Re: FortisBC Energy Inc. (FEI)

Application for a Certificate of Public Convenience and Necessity (CPCN) for the Pattullo Gas Line Replacement Project (the Application)

Response to the Commercial Energy Consumers Association of British Columbia (CEC) Information Request (IR) No. 1

Forecast Peak Demand 30.2DD - Pattullo Gas Line (m³/hr.)

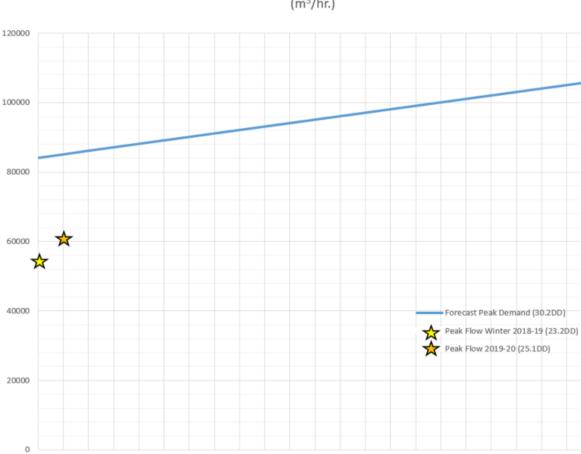
- 14
- 15 5.4 Please provide a graph showing the past 2 year peaks and forecast peak 16 demand projection over time for the Pattullo Gas Line.
- 17

- 19 The graph below shows the forecasted peak demand expected for the Pattullo Gas Line over
- 20 the next 20 years. Also shown is the measured flow over the Pattullo Gas Line on the coldest
- 21 day in the winter of 2018-19 and the winter of 2019-20.

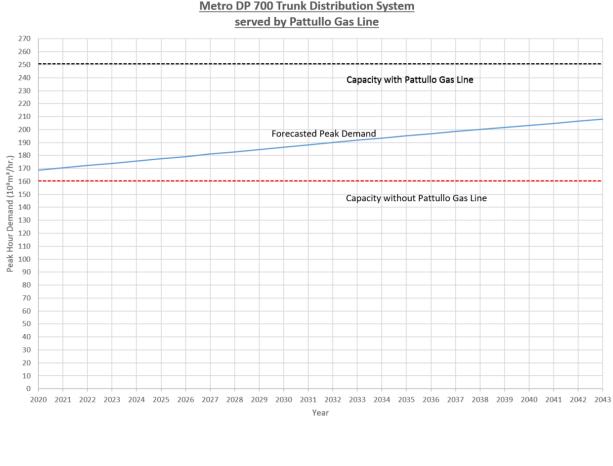
5.5 Please illustrate graphically the area's peak demand and the available supply both with and without the Pattullo Gas Line.

9 The following figure provides peak demand and available capacity, both with and without the
